ELECTRICAL SAFETY INSPECTION REPORT

RIO FASHION WEAR LTD. & RIO DESIGN LTD., DHAKA, BANGLADESH

Inspected on November 02, 2013

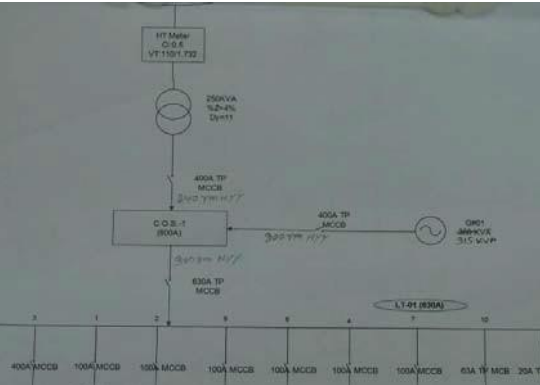
Finding #: E- 6	
Category: TRANSFORMER ROOM	
Finding: Transformer output (LV side) is connected through MCCB (In=400A) and is not enclosed (directly mounted on the wall).	
Recommendation: The MCCB may be installed in standard enclosures and must be protected. Cables terminating at the MCCB must be firmly fixed with cable glands. Install phase barrier between MCCB terminals.	
Remediation Timeframe: Within 1 Month	MCCB installed on the wall (Transformer room) without enclosure.

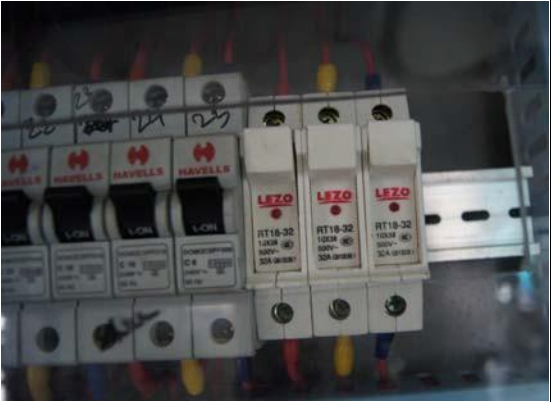
Finding #: E- 8	
Category: TRANSFORMER ROOM	
Finding: Earth Lead (from earth electrode) installed is not sized adequately.	
Recommendation: Earth lead must be replaced by higher cross-sectional area.	
Remediation Timeframe: Within 1 Month	Main earth bus terminating the main earth conductor from the electrode.

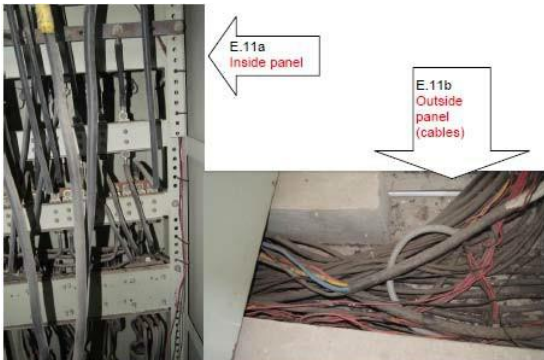
Finding #: E- 10	
Category: GENERATOR ROOM	
Finding: Cables terminating at generator terminal box are not supported and not firmly fixed.	
Recommendation: Cables terminating at generator terminal box must be supported and protected. Existing cables in flexible PVC conduit must be additionally supported. Cables may be supported in risers and securely fixed to the terminal box installing cable glands.	
Remediation Timeframe: Within 1 Month	Cables in flexible PVC conduits terminating at MCCB termination box.

Cables entering panel (in open trench) and inside the same panel.

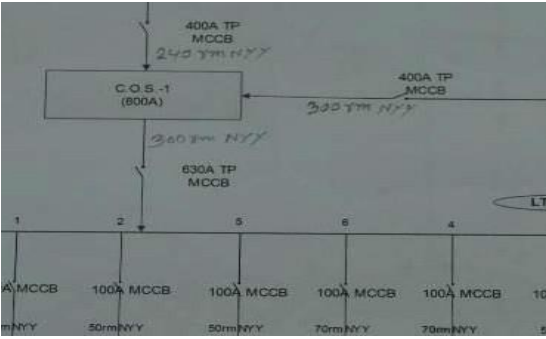
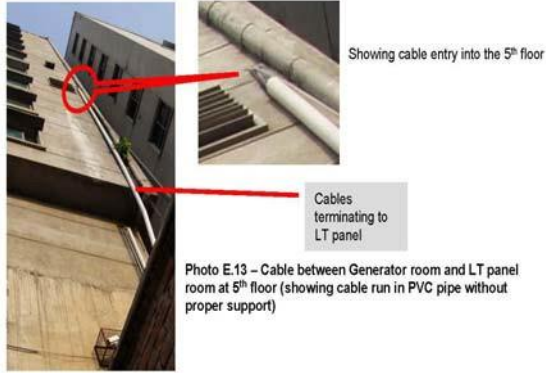
Finding #: E- 18	
Category: SWITCHBOARDS AND PANELS	
Finding: Panels are not installed with required safety features.	
Recommendation: a) Panels must be fixed with gland/base plates and must be protected from entry of dust, mice, insects and other small animals. b) Cable terminating at the panels must be firmly attached with proper glands. c) Cable inside the panel must be terminated with proper lugs/terminals	
Remediation Timeframe: 3 Months

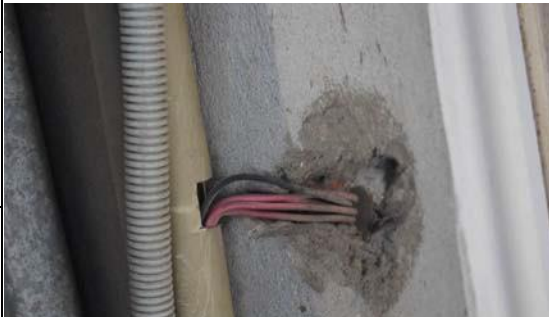
Finding #: E- 22	
Category: CABLE AND CABLE SUPPORTS	
Finding: Power Cable delivering power to the LT panels at 5 th and 7 th Floors are not supported and directly passes through wall opening.	
Recommendation: The cables from Generator Room to 5 th and 7 th floors must be properly clipped/mounted on cable tray/ cable ladders from Generator output panel to Changeover panel. The cable ends must be firmly fixed to the gland/base plate of respective panels. Entry into the floors must be protected by installing conduits and cable must not be stressed.	 Photo E-13 – Cable between Generator room and LT panel room at 5th floor (showing cable run in PVC pipe without proper support)
Remediation Timeframe: Within 1 Month	Main cables installed outside building and in large PVC pipes but not supported/fixed at regular intervals.

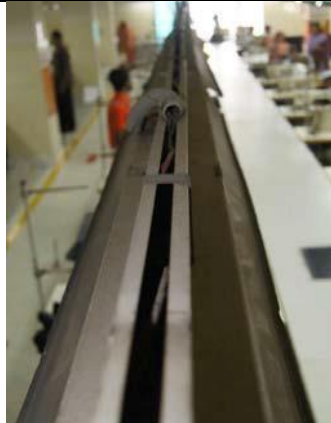
Finding #: E- 23	
Category: CABLE AND CABLE SUPPORTS	
Finding: Wire joints and spliced in between terminals. Wires in trays or ducts are not protected.	
Recommendation: Wiring between floors must be replaced with proper size cables. Joints between terminals must be avoided and where not avoidable, must be joined installing standard cable/wire jointing kits.	
Remediation Timeframe: 3 Months (refer E-24)	Bunch of wires between floors without supports and protections. Some of the wires in it are joined.
